Engineering Analysis of the FCC Order on Remand

April 10, 2003

V-COMM has prepared this report and provides an engineering analysis of the technical issues and statements made within the FCC's Order on Remand (Order), with regards to the AirCell waiver.¹ In this Order, the Wireless Telecommunications Bureau affirms its granting of AirCell and its cellular licensee partners waivers of section 22.925 of the Commission's rules.

Figure 7-A Reproduction of AT&T's Figure 8: Uplink Carrier CDF for Sherman-Denison, 2261 data points, Approx. 10 Cells (submitted to Commission on Dec. 15, 1997)

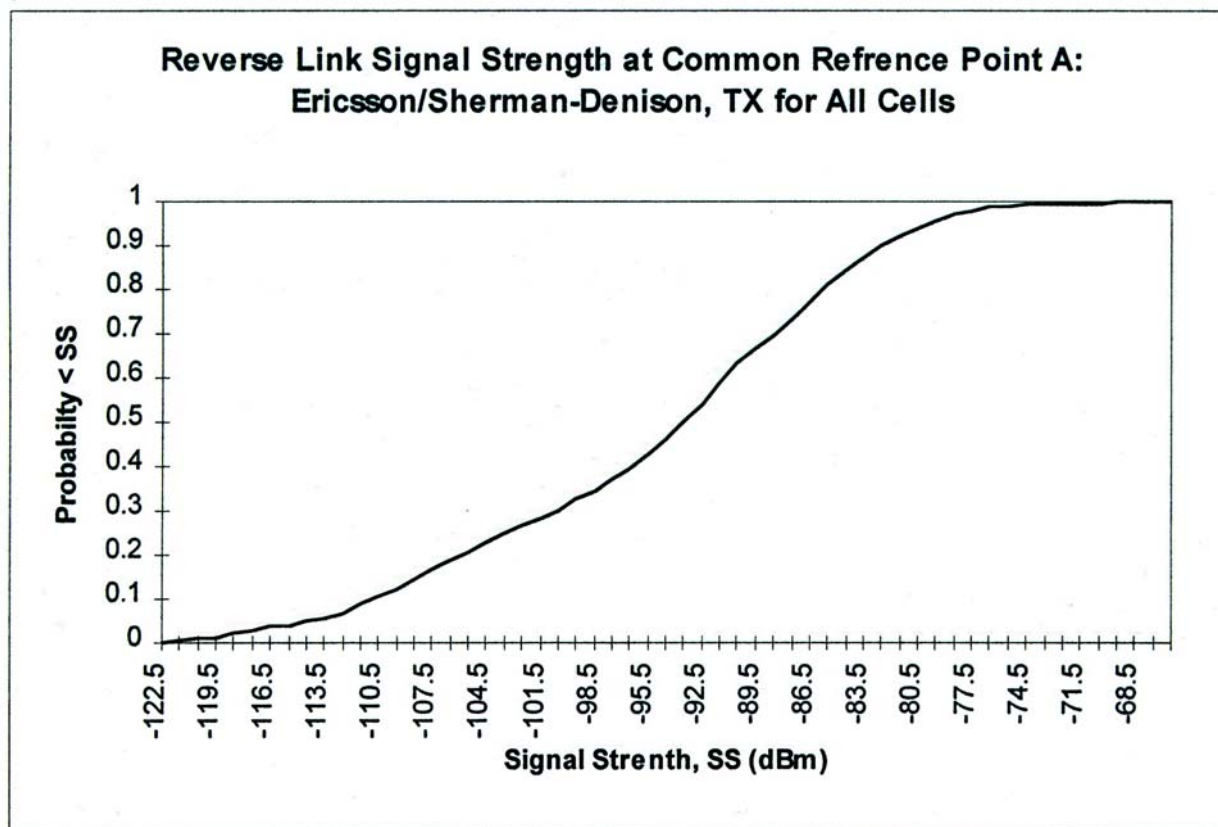
The FCC did not consider AT&T Wireless' signal level measurements that were recorded and submitted in the record at that time for analog cellular base stations.⁹ These measurements indicate that approximately 30% of wireless calls are received below -100 dBm, and approximately 20% of wireless calls are received below -105 dBm. These reverse-link measurements were conducted on a variety of cells (approx. 10 cells in total, including suburban and rural), within its Sherman-Denison MSA market.

With very low operating noise floor conditions and acceptable call quality thresholds, a significant amount of cellular traffic is handled between -100 dBm to -110 dBm, which the Commission should not disregard. V-COMM recorded approximately 35% of customer traffic for analog service being served between -100 and -110 dBm, at a typical suburban base station in the Trenton, NJ MSA. In AT&T Wireless' submitted data in the 1997 record,¹⁹ it measured approximately 20% of its customer traffic at signal levels between -100 and -110 dBm. This represents a significant amount of cellular traffic, which the Commission is not considering since it assumed the minimum call level is -100 dBm. Again, it should be noted that rural sites with larger coverage areas would exhibit even greater percentages of calls within the -100 to -110 dBm levels.

Figure 7-B Flight Profile & Affected Terrestrial Sites, Slant-45 Terrestrial Antenna, Average Signal Level, IAP -110 dBm

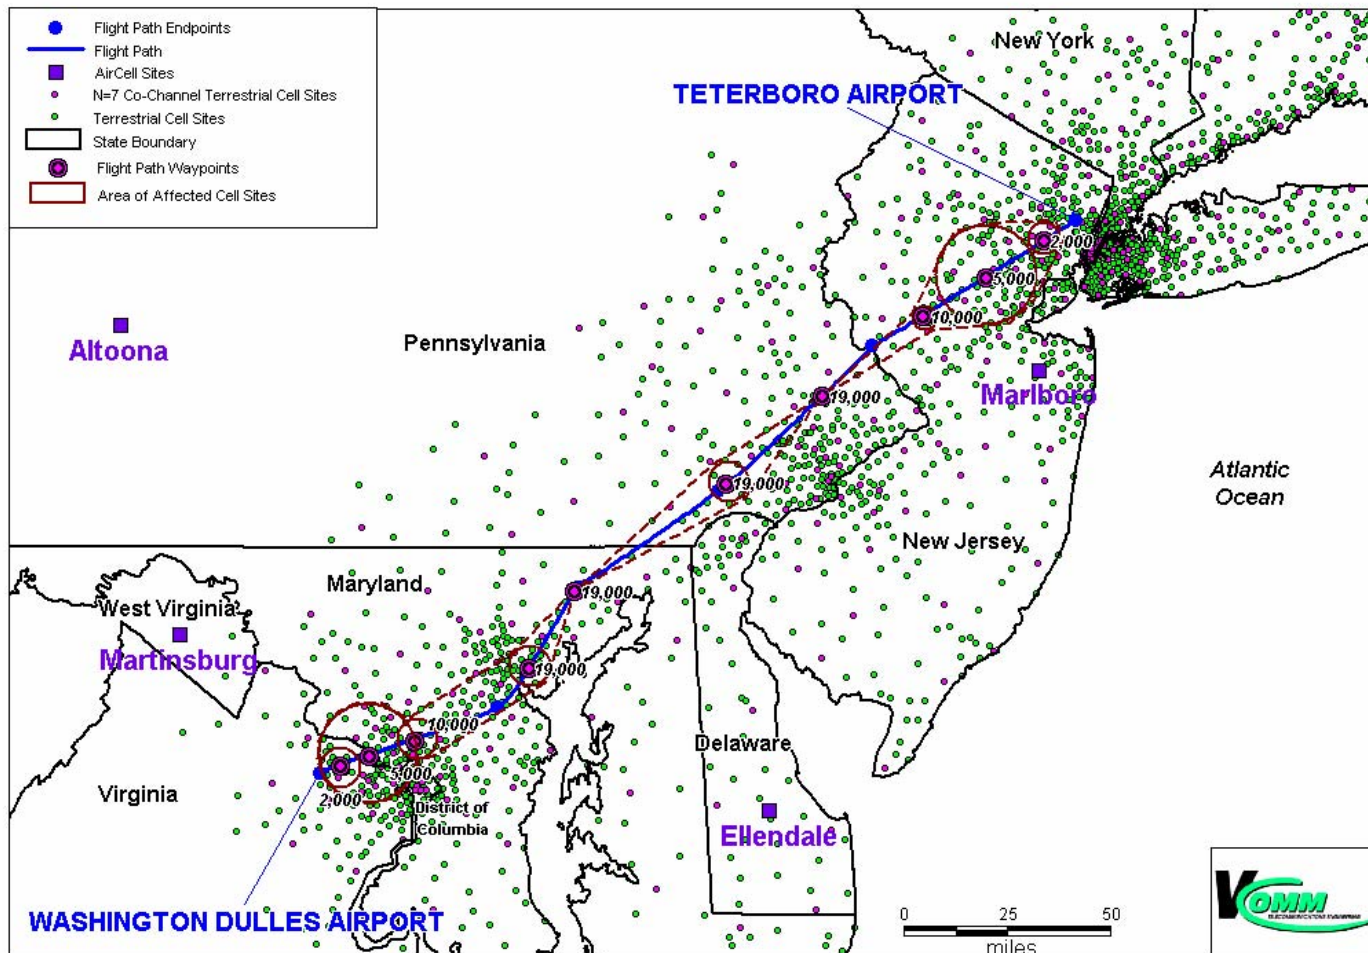
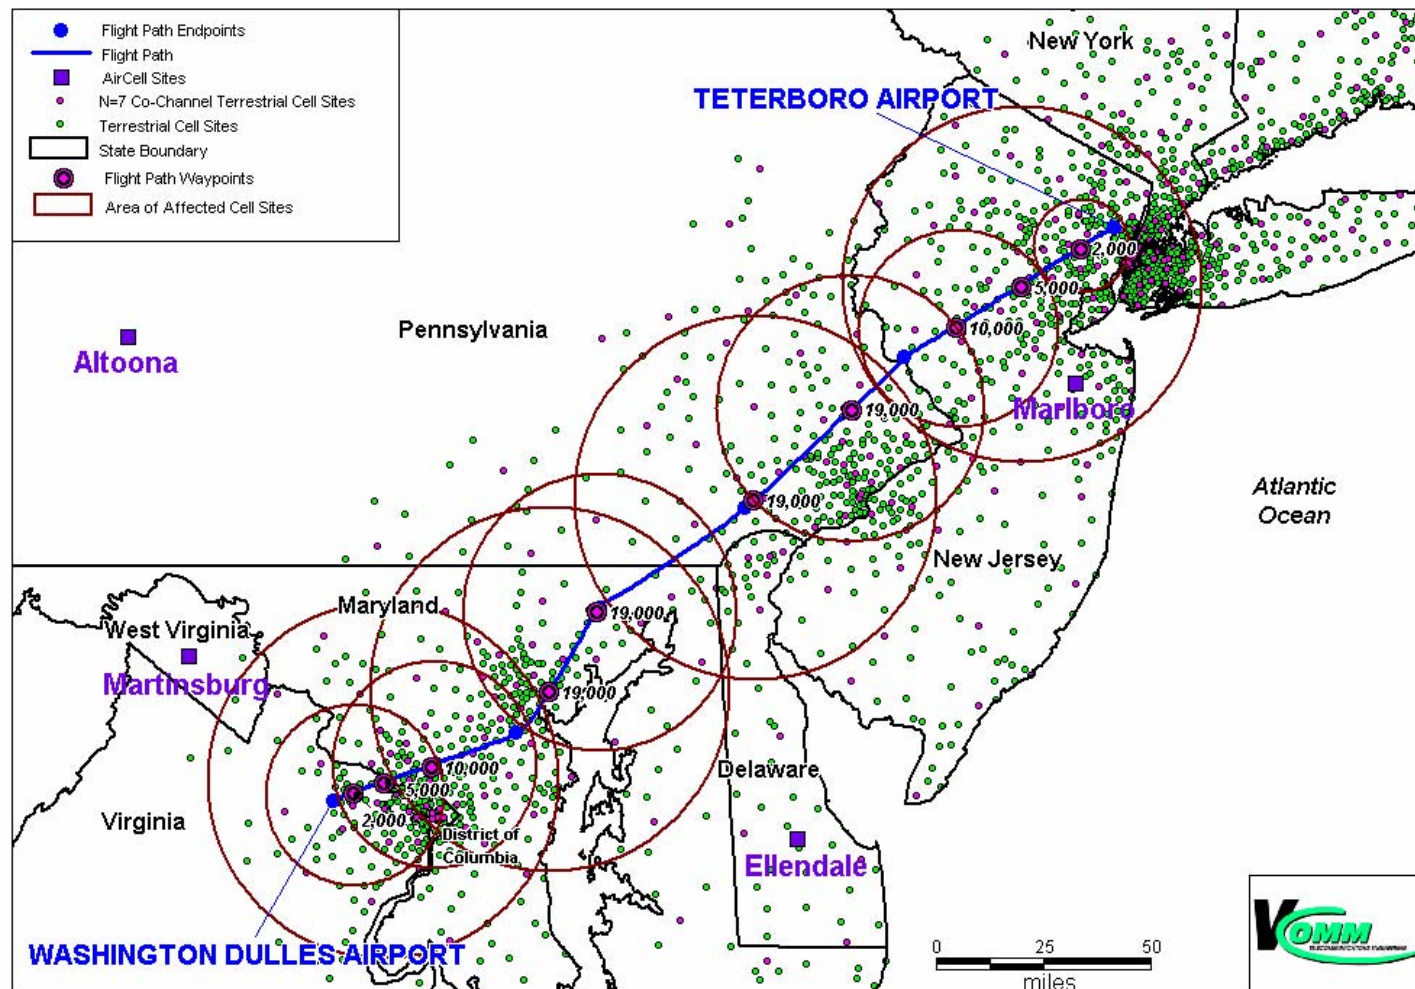
³³ As depicted in a case study in the "Engineering Report of the AirCell Compatibility Test", the impact of a typical flight can potentially cause harmful interference to over 200 AMPS terrestrial sites and 200 AMPS terrestrial telephone calls. This utilizes an interference analysis point of – 114 dBm, showing an AMPS service degradation of 12 dB in median C/I, 0.2 unit decrease in MOS audio quality, and the 90% C/I degradation to a C/I of 10 dB, for a typical suburban site with 1.5 mile coverage radius.

Using the FCC's threshold for harmful interference for analog cellular systems, it can be demonstrated that significant harmful interference will occur to many cellular sites along a typical flight path. For the case study flight profile that was described in the *Engineering Report of the AirCell Compatibility Test*, and using an interference threshold of -110 dBm, it is observed that a significant number of co-channel analog cellular sites would experience harmful interference along this typical flight path. As provided in Appendix Section 7.3 of this report, the number of co-channel analog cellular sites meeting or exceeding this threshold for the slant-45 degree terrestrial antenna is 43 cell sites.³⁶ Also, using the same case study and the 90% AirCell signal levels received at the terrestrial sites, yields 185 cell sites with harmful interference.³⁷
